TECHNICAL NOTE			DTPC
from:	ALAN DAVIES	date:	11/6/2021
subject:	PROPOSED CONVERSION OF EXISTING BARN EIGHT DWELLINGS, BROCKHALL FARM GLENEAGLES DRIVE, BROCKHALL VILLAGE	file ref:	J1194-TN1

This Technical Note sets out the response to the highway feedback.

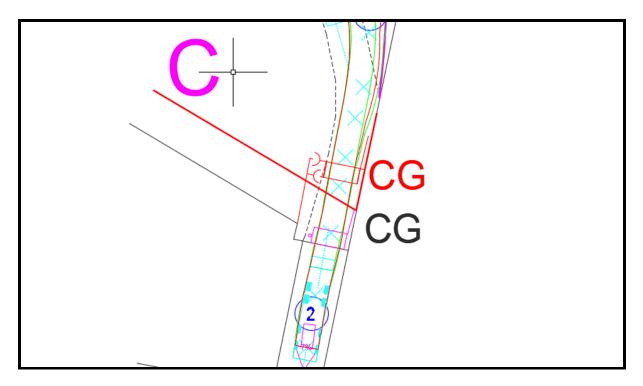
There are however concerns regarding the access along the track to the rear of Larkhill including the lack of pedestrian facilities at the cattle grid to the rear of Bradyll Court .....

The cattle grid is not in the applicant ownership from the image there is a gap to the westerly side that would allow walkers etc to pass the cattle grid. However, this is blocked by wire as the field is perceived to have livestock in it. As such cannot deliver the suggested improvements.

However, it is possible to provide a cattle grid with pedestrian gate to the site and a stock fence to ensure no livestock could get around as per drawing J1194 access fig 3 A, details to be conditioned.

The plan overleaf shows the central area in more detail and a 4.1m width in a dotted line.

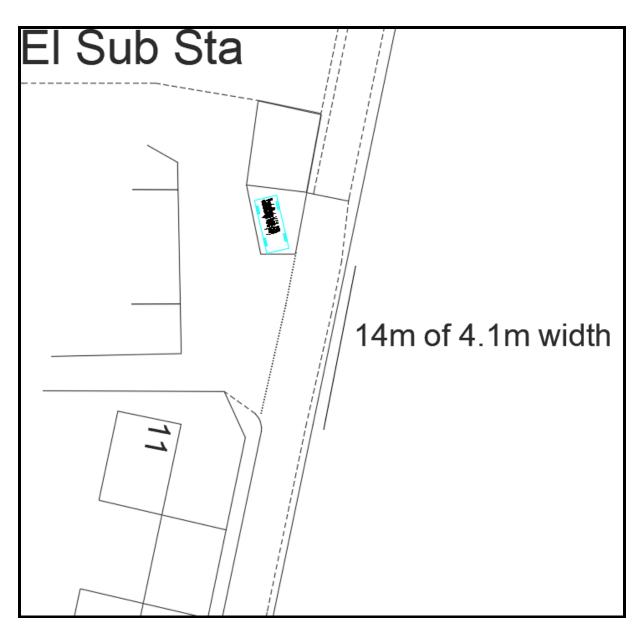
An additional passing place should be considered at the start of access track adjacent to 25 Larkhill.

The access to the farm/development is alongside existing residential units and via a route that is private and not adopted. Access rights are part of the land deeds as is a level of shared maintenance.

The following map shows the central area where access to drives/refuse turning for existing uses takes place.

The refuse could also be picking up the village needs as well as the farm, alternatively a separate waste pick up may be required if LCC do not wish to provide the service.

The route already accommodates the farms needs in terms of delivery etc as such the key area is the likelihood of conflict from the additional flows.

The report set out a robust 0.7 two way trips rate thus 4 out 2 in AM and 4 in 2 out PM.

Thus 1 per 30 minutes opposed by 1 per 15 minutes, the potential for conflict is low and highly unlikely.

Although not to full adoptable standards it is considered the route can accommodate the increase in flows with little or no additional conflict locally.
